**CONTRACT CHANGE ORDER**No. 002Date 03/02/2022EDF # 20-040

Contract No. WWTP-2021-48 for the following public work: 2021 Wastewater Treatment Facility Upgrades Project between C.D. Smith Construction, Inc. and the City of La Crosse, dated April 8, 2021, is hereby changed in the following particulars, to-wit:

**CHANGE ORDER NO. 002**

CHANGE ORDER DATE OF ISSUANCE	<u>March 3, 2022</u>	COMMENCEMENT OF CONTRACT TIME	<u>May 3, 2021</u>
OWNER	<u>City of La Crosse</u>		
CONTRACTOR	<u>C.D. Smith Construction, Inc.</u>		
PROJECT	<u>2021 Wastewater Treatment Facility Upgrades</u>	EDF NO.	<u>20-040</u>
ENGINEER	<u>Donohue &amp; Associates, Inc.</u>	CONTRACT NO.	<u>13655/13735</u>

**CITY OF LA CROSSE**  
**2021 WASTEWATER TREATMENT**  
**FACILITY UPGRADES**  
**LA CROSSE WISCONSIN**  
**SITE DEVELOPMENT**  
**REMOVAL PLAN**

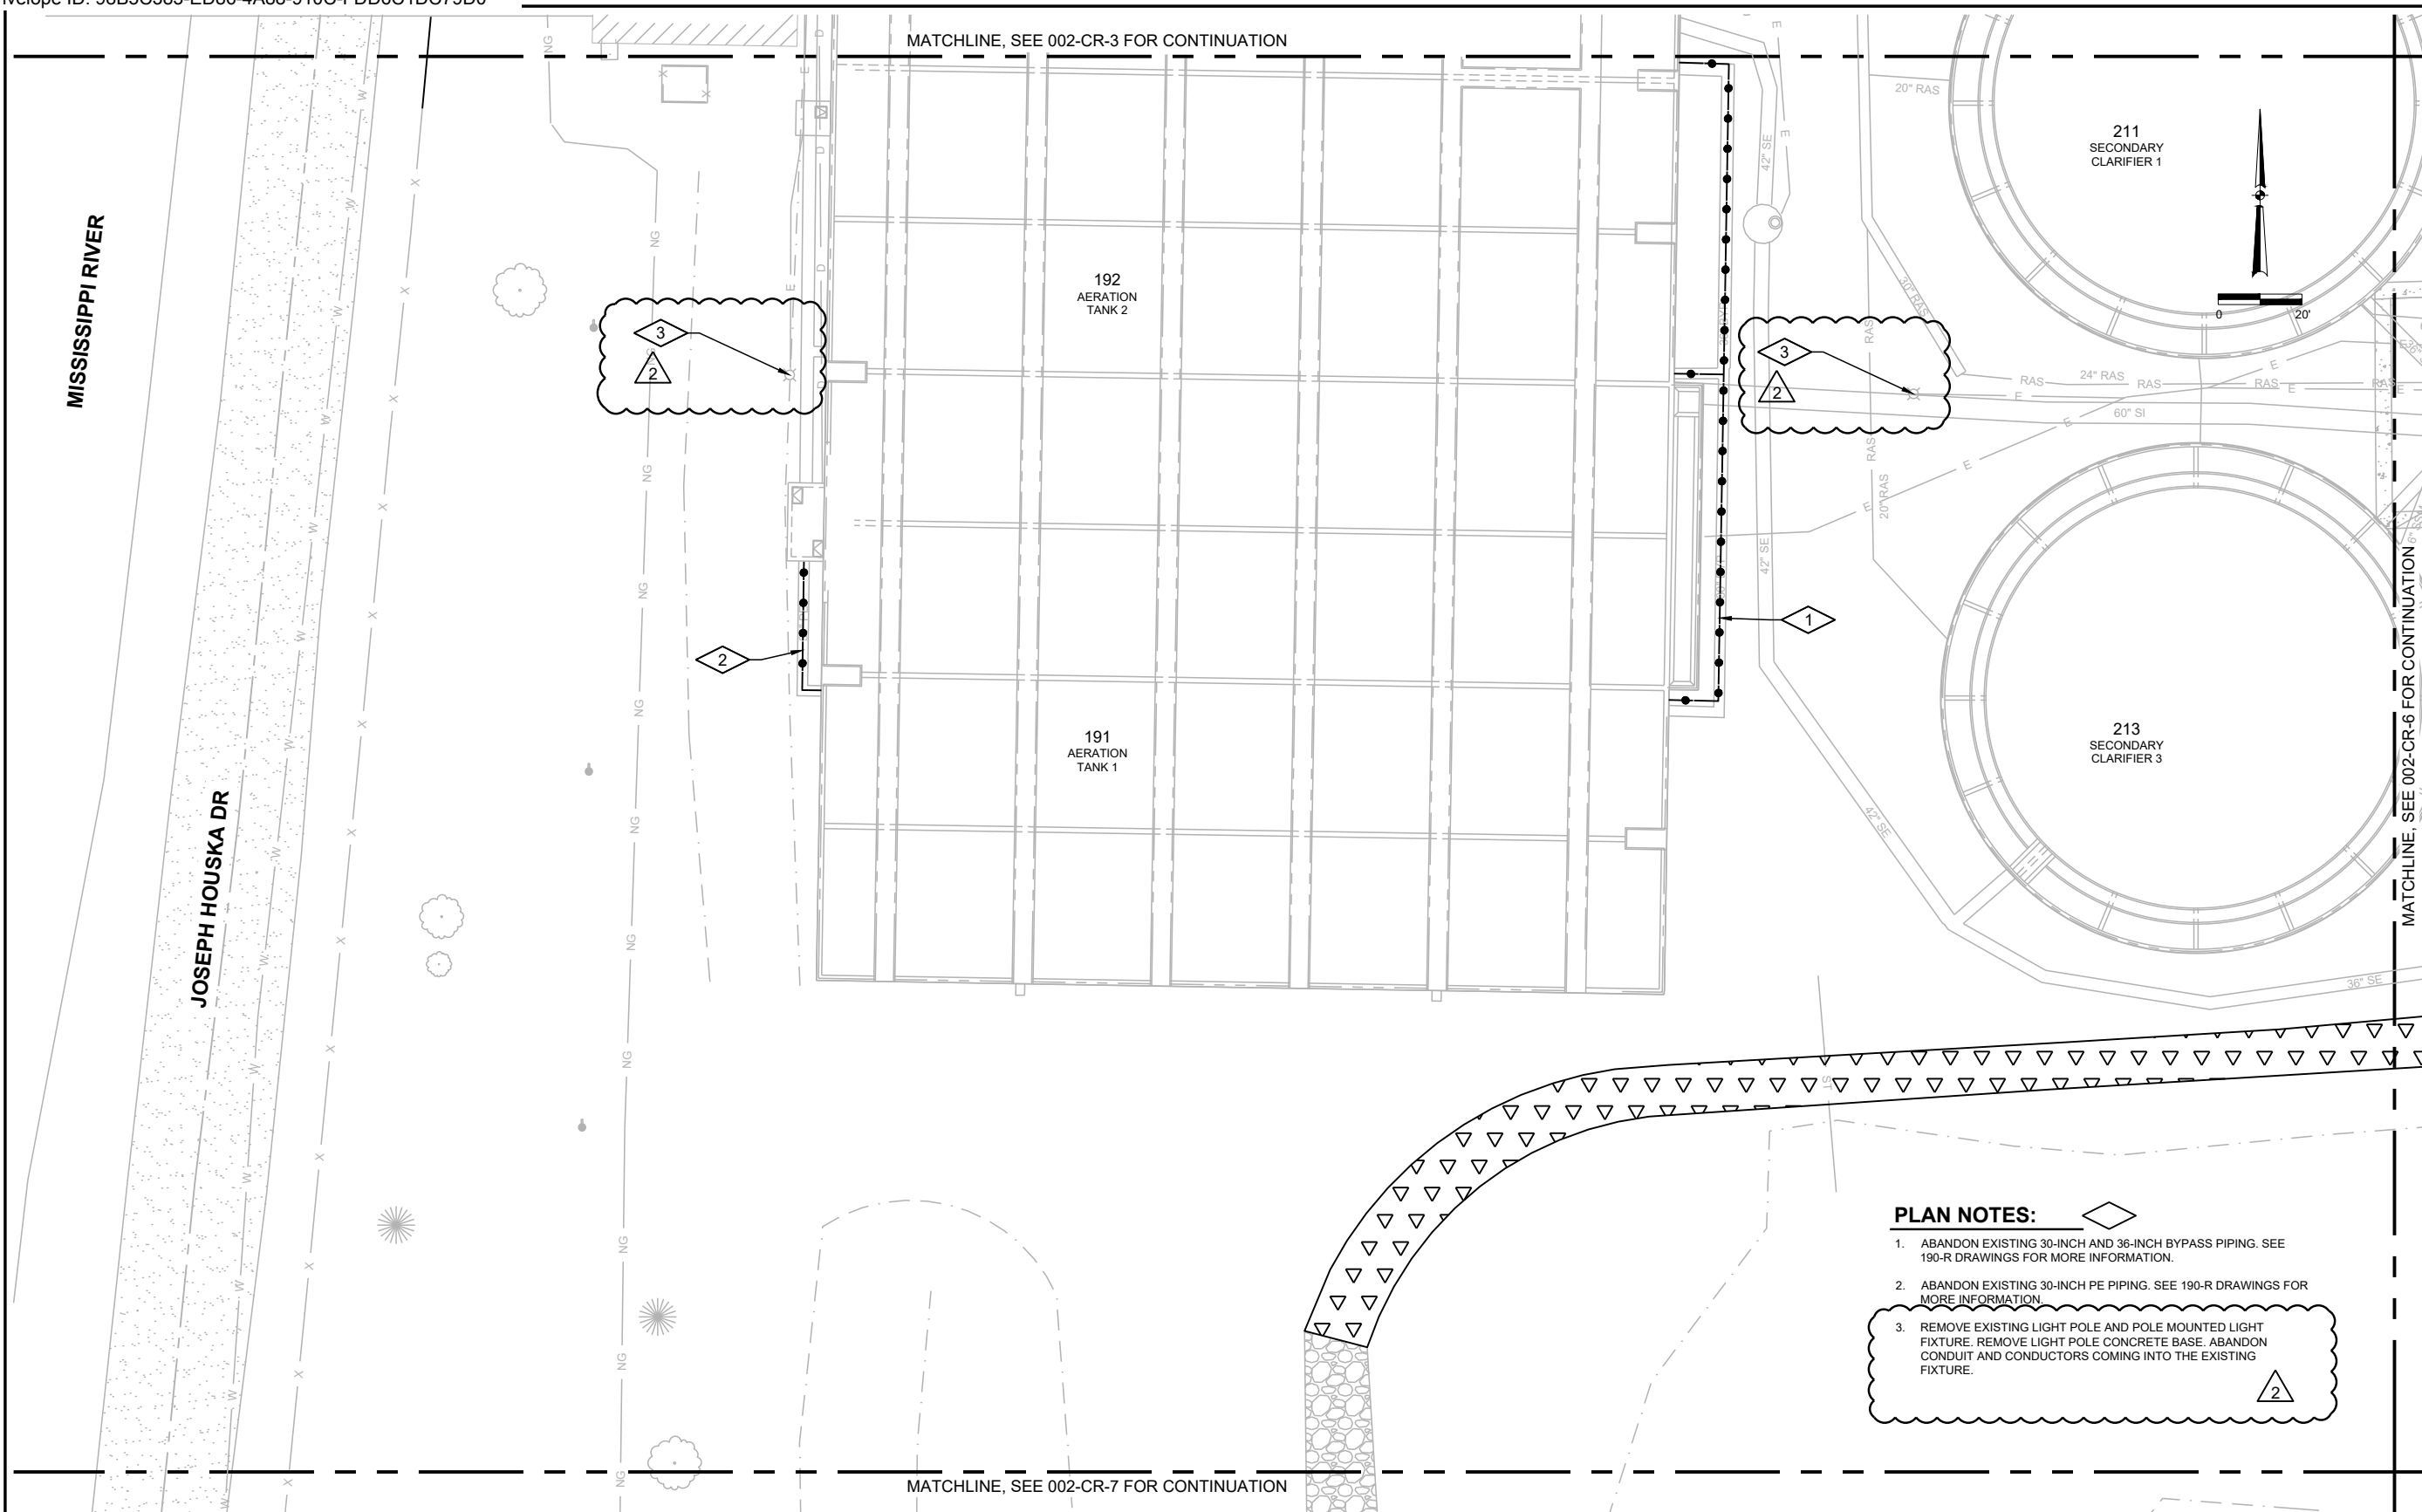
1. Provide temporary construction fencing south of the City of La Crosse School District Cold Weather Storage Building and north of Anaerobic Digester 2 and Liquid Biosolids Storage Tank 1. Temporary fencing shall encompass temporary waste gas burner location.

2. Replace temporary construction fencing with permanent fencing near the end of the project in accordance with attached revised drawings. Coordinate exact location with Engineer and Owner.

3. Modify asphalt limits north of the East Digester Building.
4. Modify natural gas and fire loop pipeline routes on the north side of East Digester Building to accommodate new fence and revised hydrant location.

CITY OF LA CROSSE  
 2021 WASTEWATER TREATMENT  
 FACILITY UPGRADES  
 LA CROSSE WISCONSIN  
 SITE DEVELOPMENT  
 ELECTRICAL PLAN

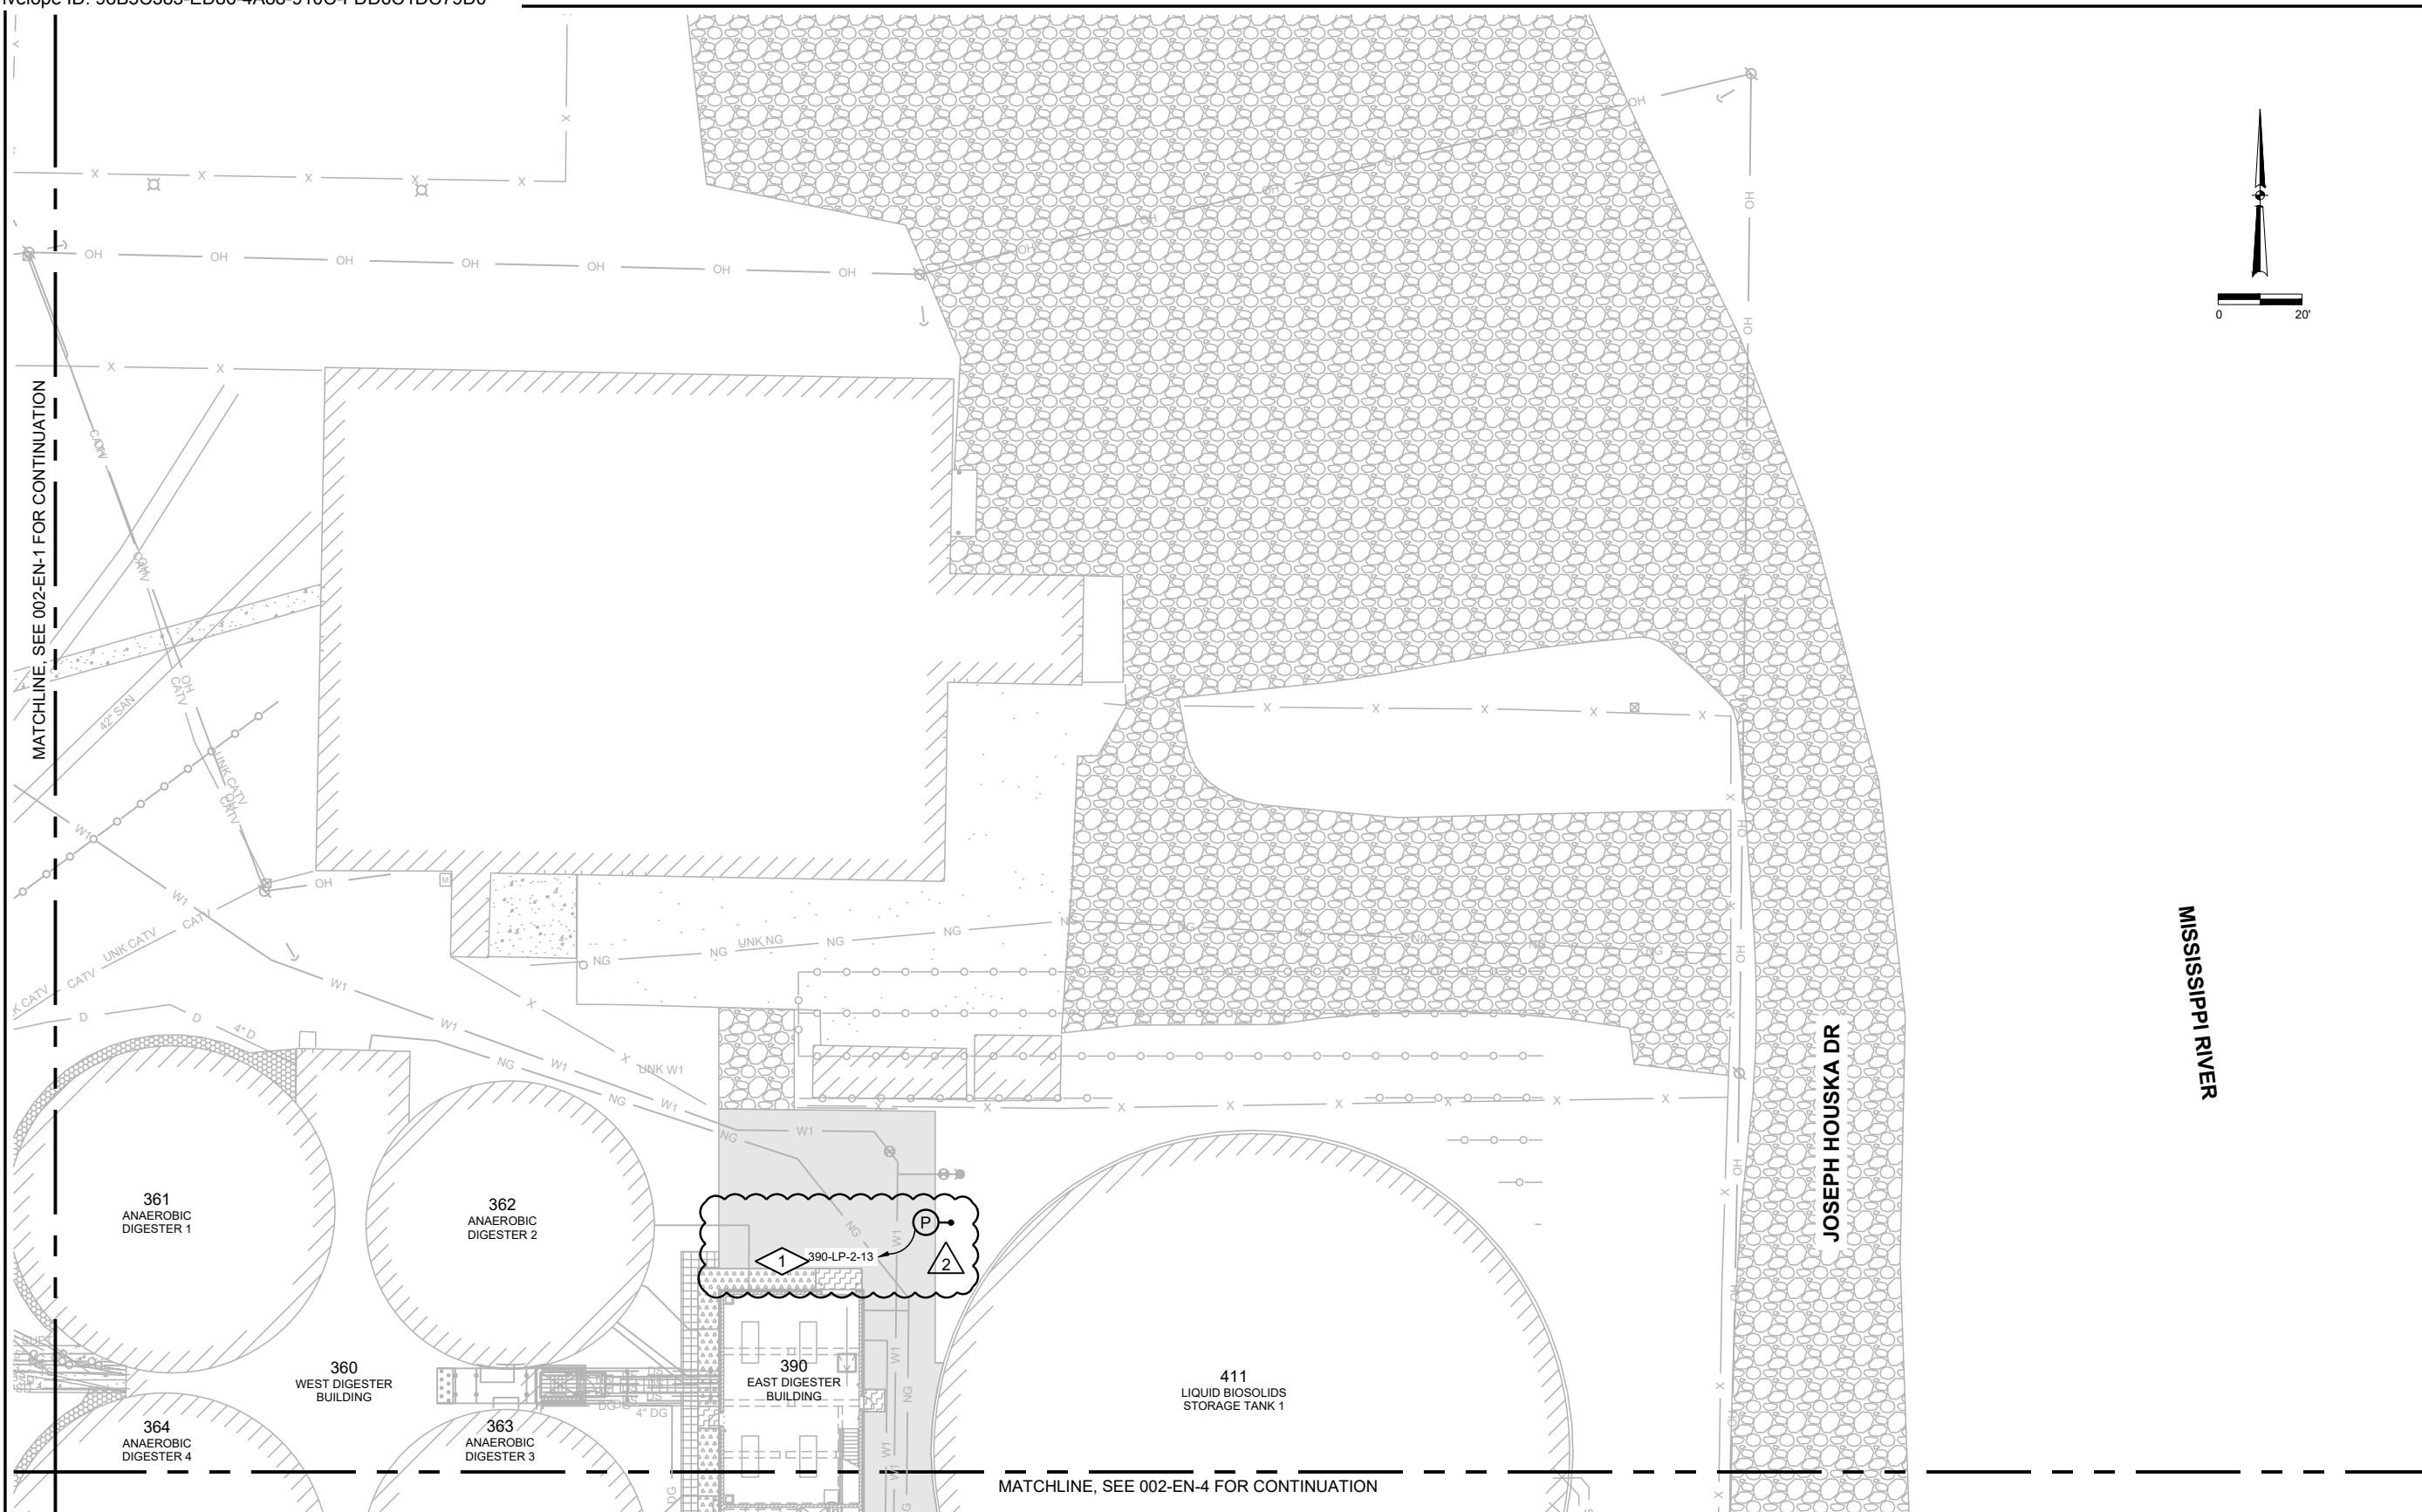
5. Modify grading on the north side of East Digester Building to accommodate new asphalt limits.
6. Provide new pole mounted light fixtures in place of removed pole mounted light fixtures and also provide new pole mounted light fixtures in the new locations shown on attached drawings. All pole mounted light fixtures on project shall be equipped with photocell.

Sheet No. 124  
Drawing No. 007-E-24

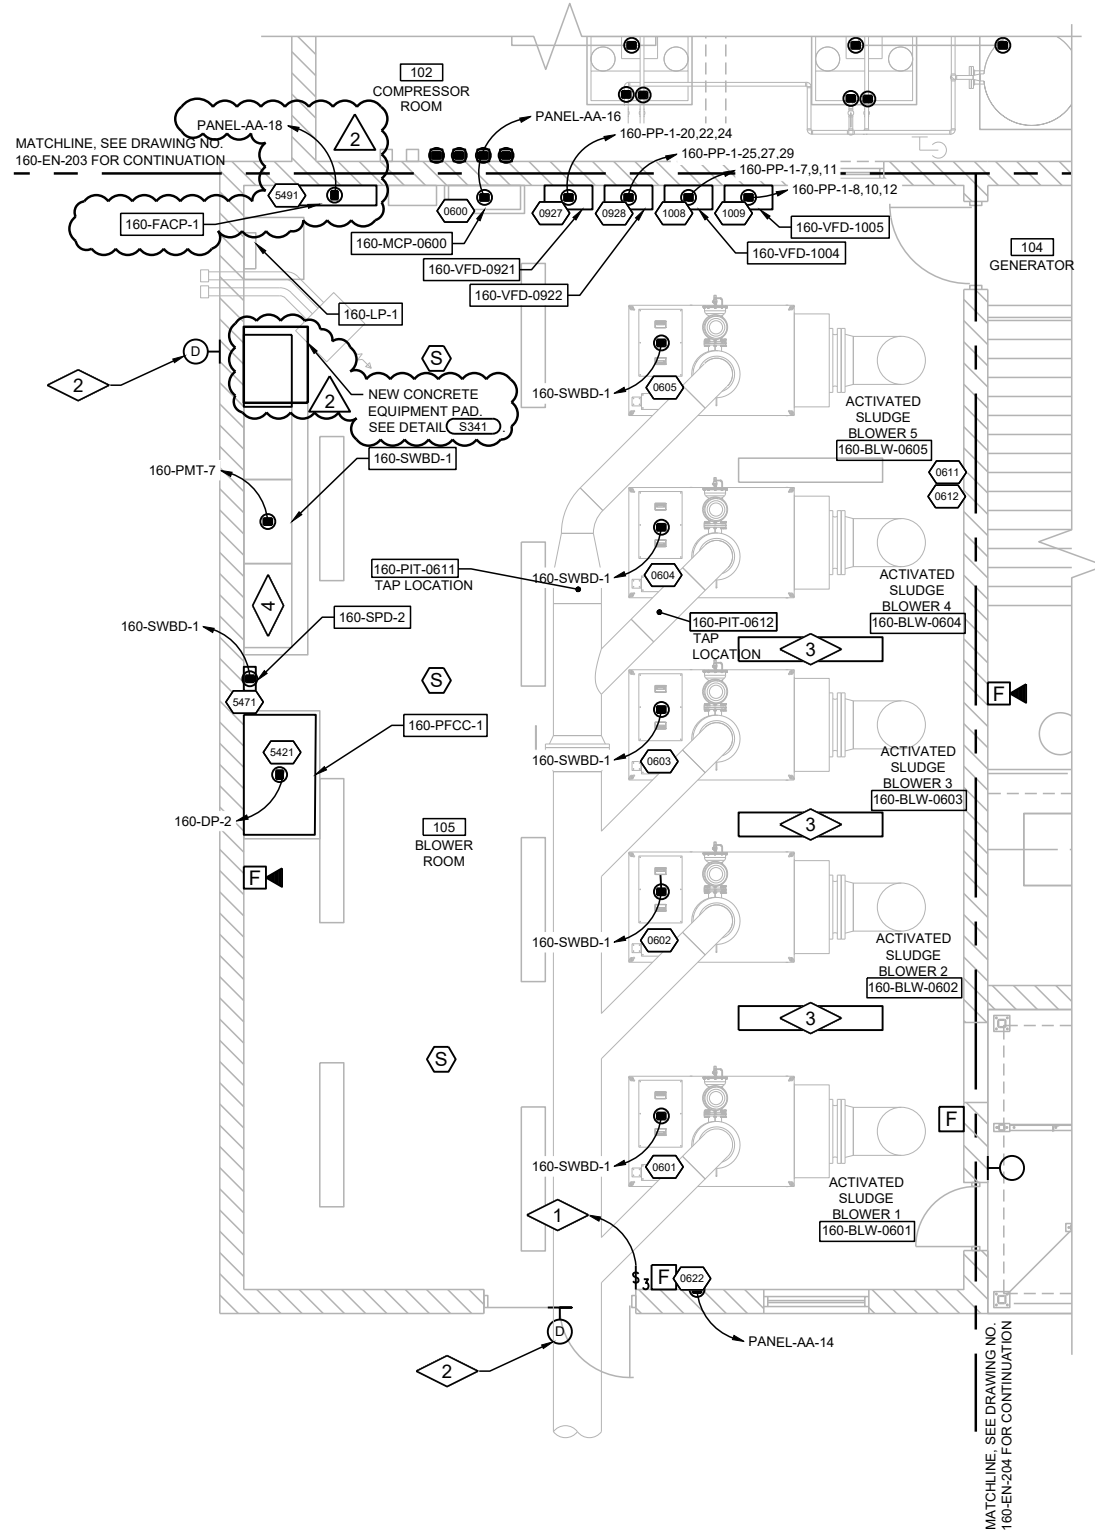
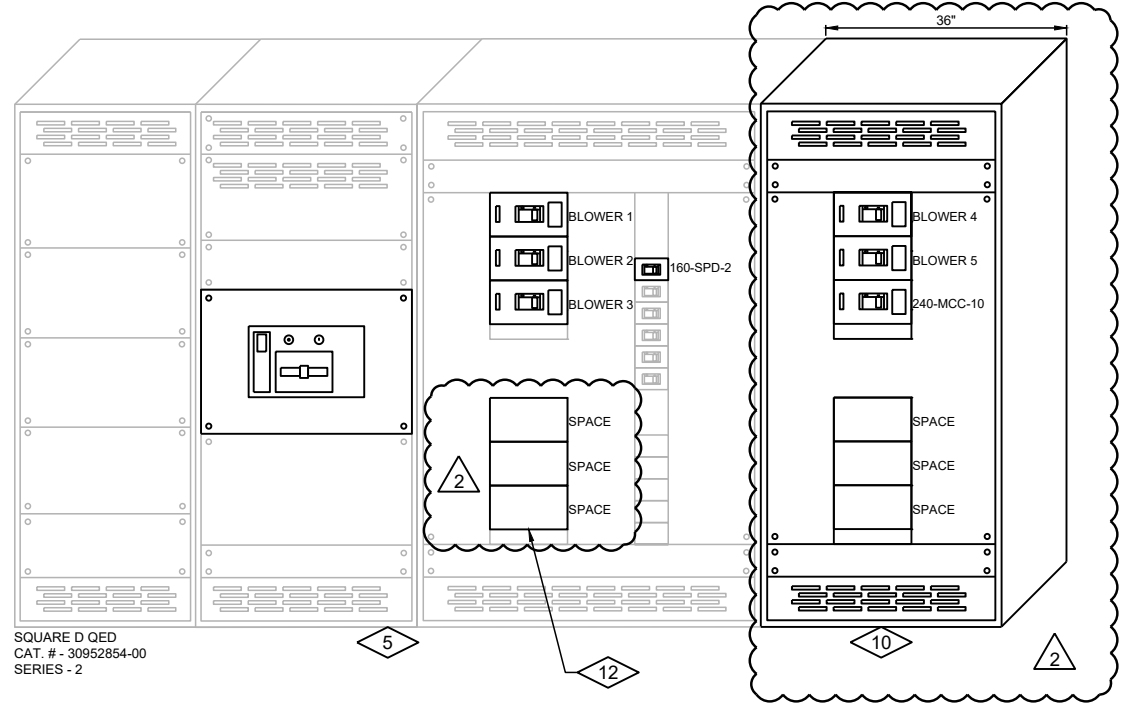
1. New distribution section without breaker. (Three of the new breakers shall be installed in this new section and shall not incur any cost)
2. New equipment pad for the distribution section.
